Randwick Local Planning Panel (Public) Meeting

Development Application Report No. D1/25

Subject: 312 Rainbow Street, Coogee (DA/850/2024)

Proposal:	Demolition of existing dwelling, removal of trees, and construction of a 2-storey dwelling house with basement level, in-ground swimming pool and pool house (outbuilding), and associated ancillary and landscaping works.
Ward:	East Ward
Applicant:	CM Studio
Owner:	S Cant & K Bright
Cost of works:	\$2,939,503.00
Reason for referral:	Over 10 unique submissions by way of objection were received.

Figure 39: Site plan demonstrating the location of the balcony at 310 Rainbow St in relation to the proposal.

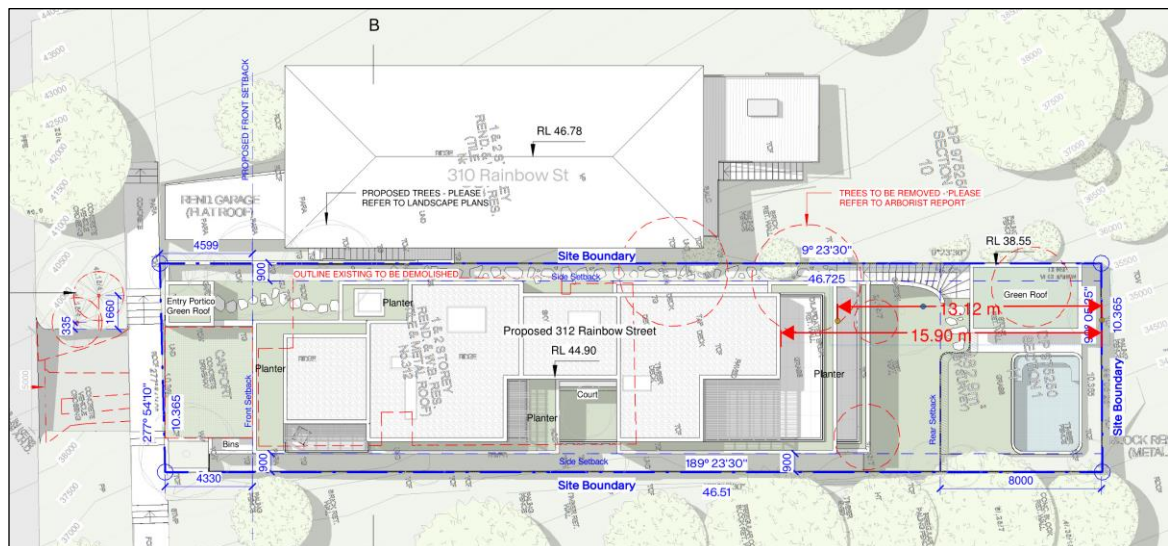
The view corridor to the east and northeast is expected to be severely impacted with most of the view lost from the rear balcony and all of the views lost from inside the dwelling. Please refer to Figures 40 – 45 for photomontages provided in a submission.

Figure 40: Montage provided demonstrating the expected impact on 310 Rainbow Street from the rear deck (Source: AE Design)

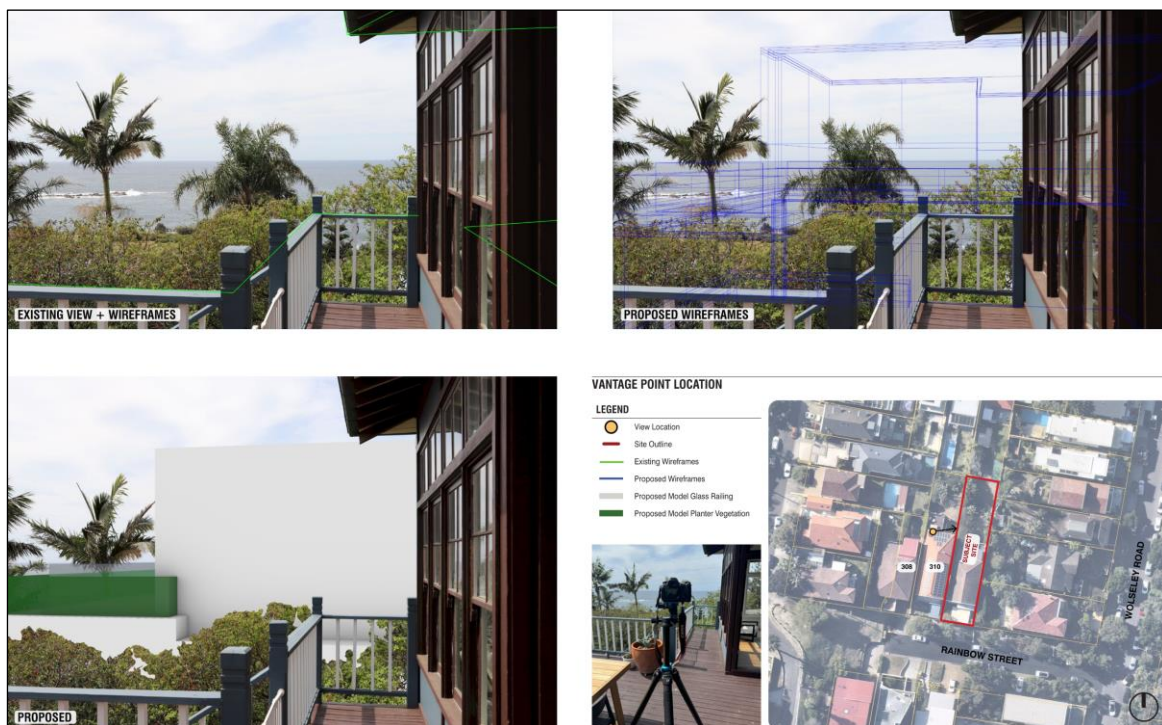
However, the montages provided do clearly show the severe to devastating impacts on views for 310 Rainbow Street.

Figure 46: Montage provided demonstrating the expected impact on 308 Rainbow Street from the rear garden (Panorama View) (Source: AE Design)

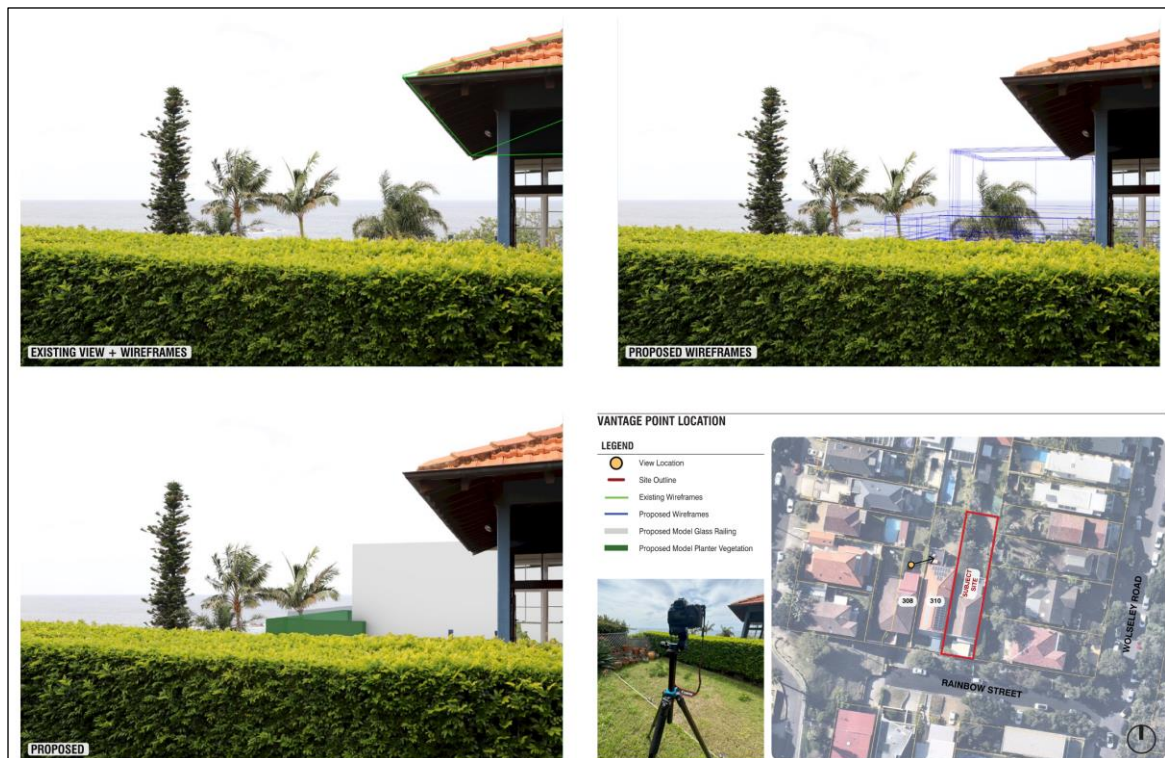
It is unlikely that most of this existing view will be affected, as shown in the Aerial Image below. However, the Applicant must confirm this. The photomontages in Figure 46 demonstrates the impact on 308 Rainbow Street from a certain position in the rear garden.

Figure 47: Applicants submitted architectural plans identifying Ground Floor GFA including Assessment Officer's markup of GFA calculation in red.

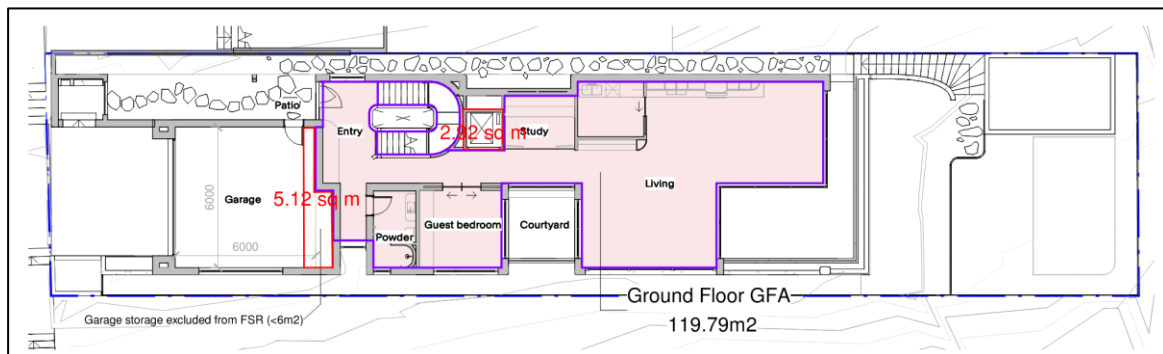
The GFA has been calculated by the Assessment Officer as 321.34sqm, producing an FSR of 0.67:1 (refer **Figures 47 & 48**). This results in a departure from the development standard that requires a Clause 4.6 variation statement, which has not been submitted.

Figure 48: Applicants submitted architectural plans identifying Basement GFA including Assessment Officer's markup of GFA calculation in red.

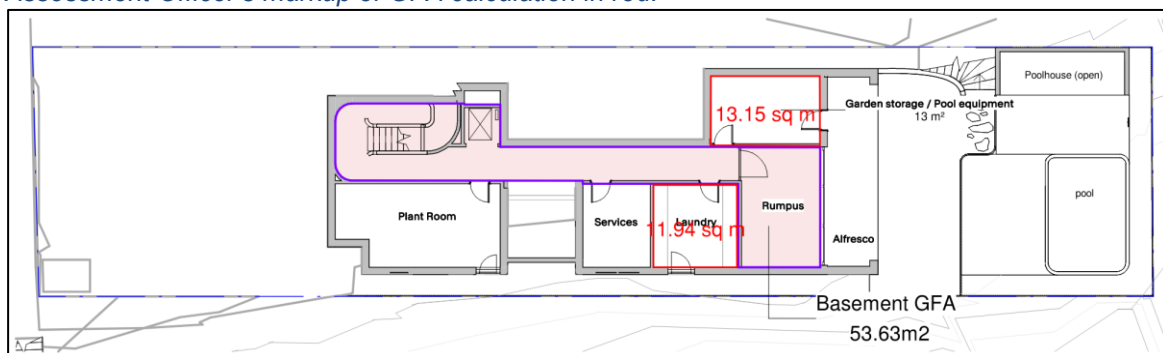
The 'garden storage / pool equipment' room does not meet the Randwick LEP definition of a 'basement' as the floor level of the storey immediately above is greater than 1 metre above ground level (existing) and has therefore been included as GFA (**see Figure 49**). The 'laundry' within the 'basement' level meets the GFA calculation definition and therefore must be included in the calculations. The garage is in excess of the required car parking facilities which can be excluded from GFA. Lastly, the lift must be calculated towards GFA on all levels, as it is not used for common vertical circulation. As displayed, the above mark ups consider these four identified areas which were excluded from the Applicant's GFA calculations.

Figure 49: Applicant's submitted Basement Floor Plan overlaid with the Survey Plan by Assessment Officer to determine existing floor levels.

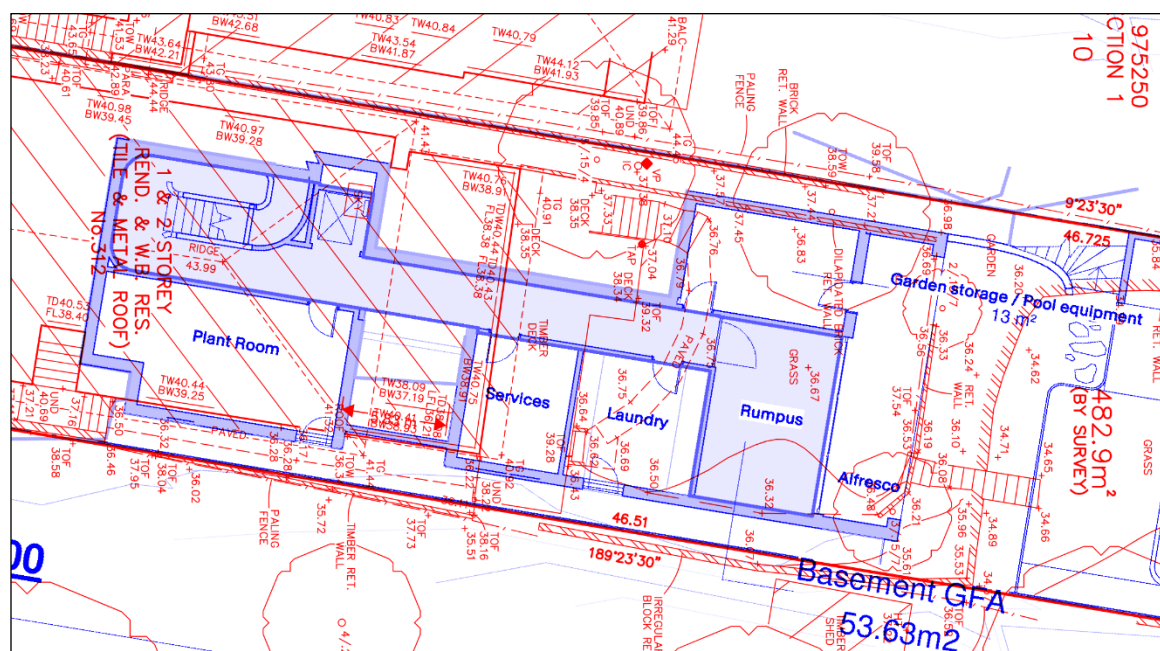
The basement level plant and service rooms include operable windows and would be capable of being utilised as habitable rooms, which would result in a GFA of 353.34m² and FSR of 0.73:1.

Figure 50: Overlay of submitted survey and roof plan marked up by Assessment Officer to create sectional diagrams of side setback non-compliance.

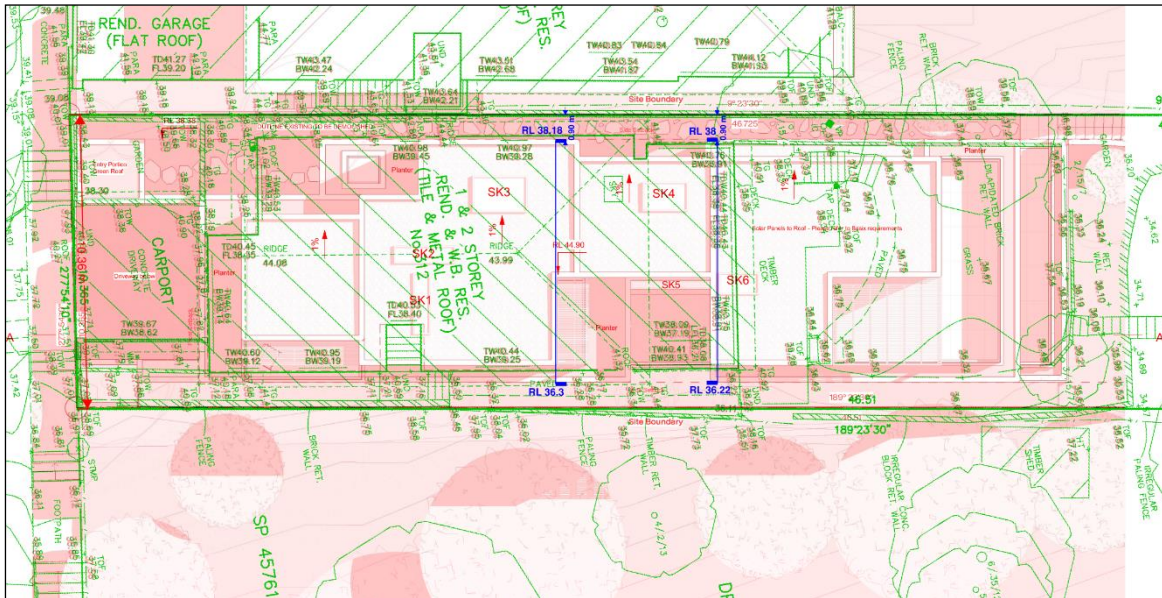
The non-compliant side setbacks will have the following impacts:

Figure 54: Elevations – West displaying covered entrance area.

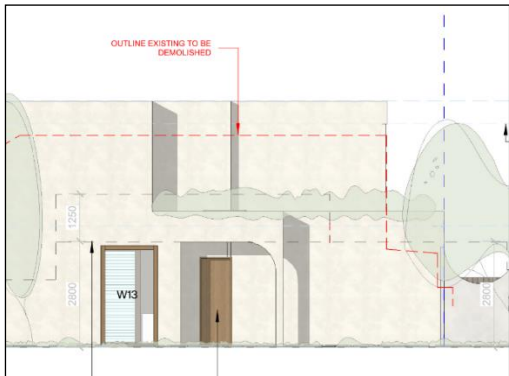
A portion of the ‘deep soil’ includes the area below the roofed entrance with stepping stones (see **Figures 54-55**), this does not meet the definition of ‘deep soil’. As the area mostly consists of paving and is undercover, the area does not provide sufficient area for water penetration or the growing of plants and therefore, is excluded from the calculation of deep soil.

Figure 56: Permeable driveway which cannot be included in the deep soil calculations

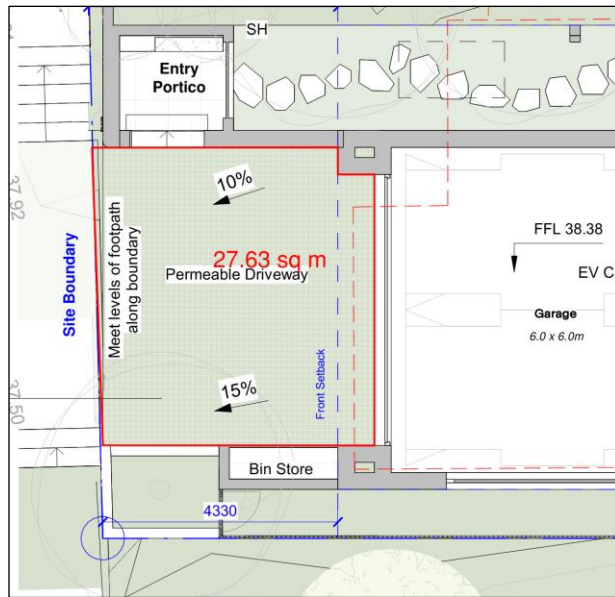
The permeable driveway cannot be included in deep soil permeable surfaces calculations because it is not an area that is used to grow plants, and will be used for vehicular access and/or parking. The courtyard on the eastern elevation cannot be included in deep soil permeable surfaces calculations because it is elevated and requires a slab to be constructed.

Because the driveway cannot be counted as deep soil permeable surfaces, the proposal does not comply with the requirement for 25% of the front setback to be deep soil permeable surfaces. This noncompliance is demonstrated in Figure 56.

Figure 60: Demonstration of potential visual privacy impacts of adjoining properties on Wolseley Road (arrows)

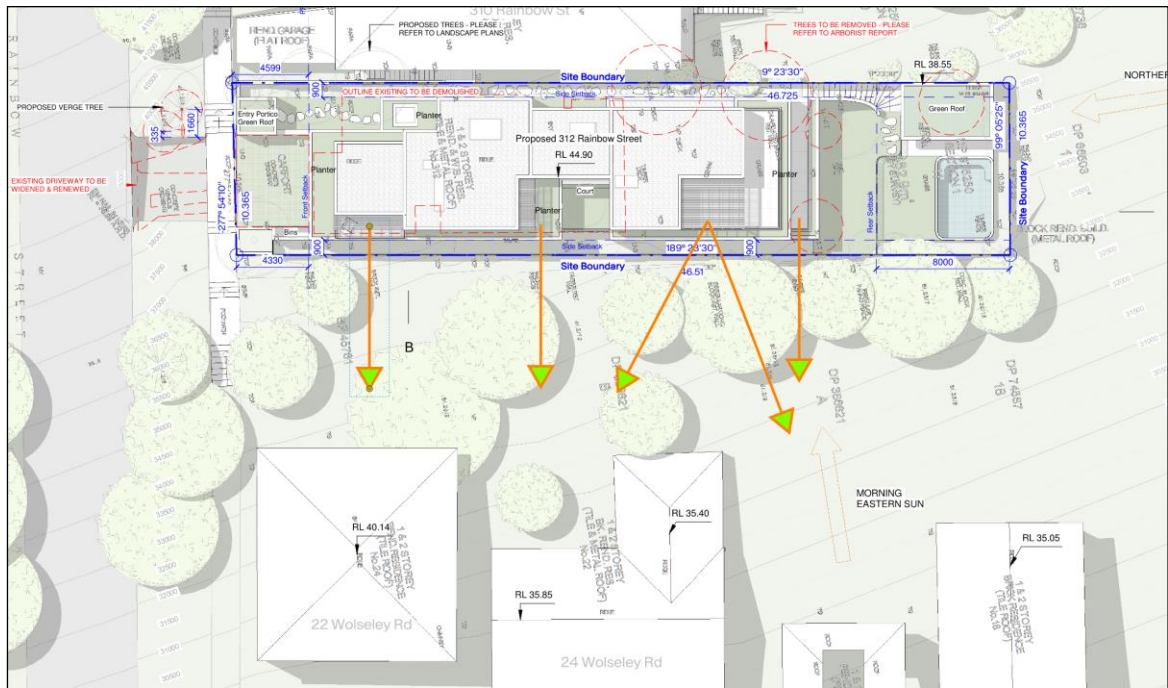
Issue	Comment
Overlooking and privacy impacts.	Council agrees that overlooking and privacy impacts are possible due to topography and size / location of proposed balconies to the north and east.
Overshadowing in winter from the bulk and height and lack of sunlight in winter.	Due to orientation Council agrees that there will be increased shadows cast during the afternoon towards the rear of the site however, as the property faces east, adequate light will be expected during the morning.

Figure 23: Deep soil permeable surfaces calculation (Source: Council)

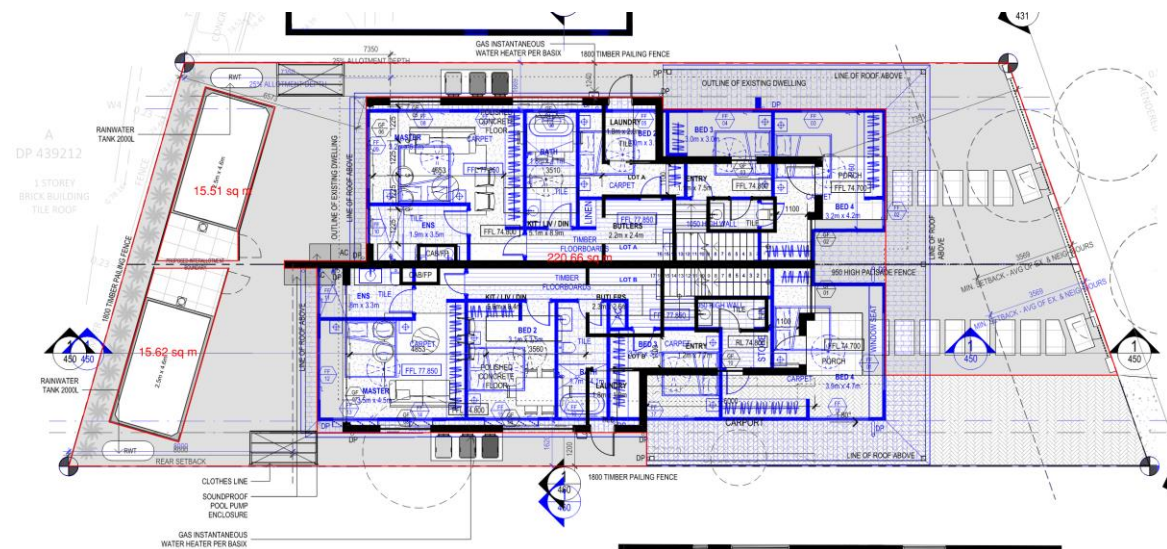
Figure 23 below details the included and excluded deep soil permeable surfaces. The areas outside the external walls have been included and the pool areas have been excluded as per the DCP definitions. The cover entrances to the dwellings have not been included.

Figure 19. Landscape Plan detailing recommended increase to deep soil area.

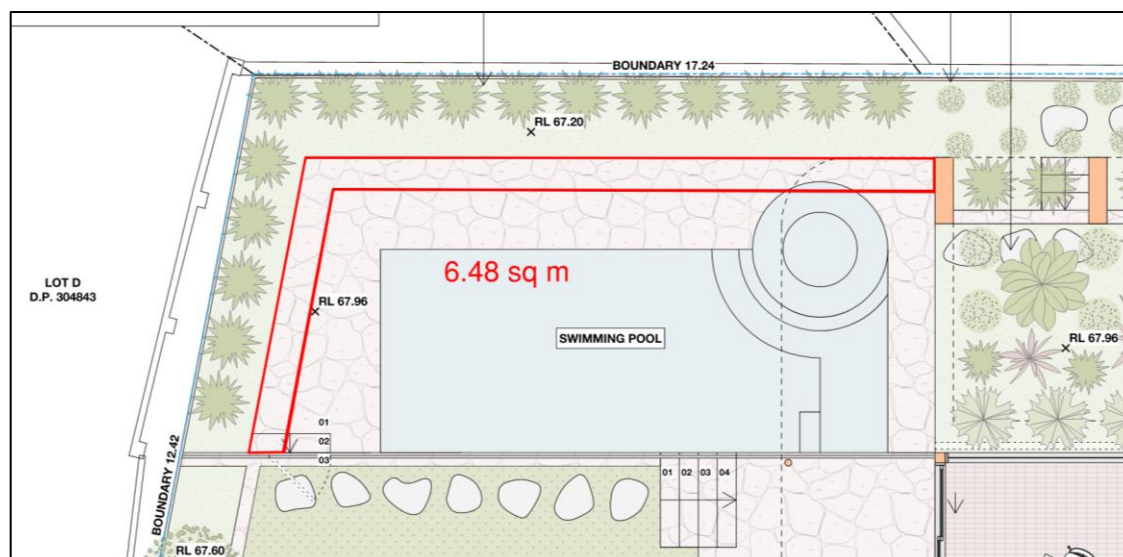
To offset the discrepancy, conditions of consent are recommended to require the extent of the paving surrounding the pool (including spa pool area) to be reduced by 500mm to the northeast and northwest boundary, and replaced with deep soil plantings (Figure 19). The amendment will provide approximately 6.5m² of additional deep soil area, bringing the development into compliance (217.5m² total/ 40% site area). This amendment also reduces the proximity of the elevated pool coping to the side and rear boundaries, and limits the width to minimise use of the area, reducing potential visual and acoustic privacy impacts.
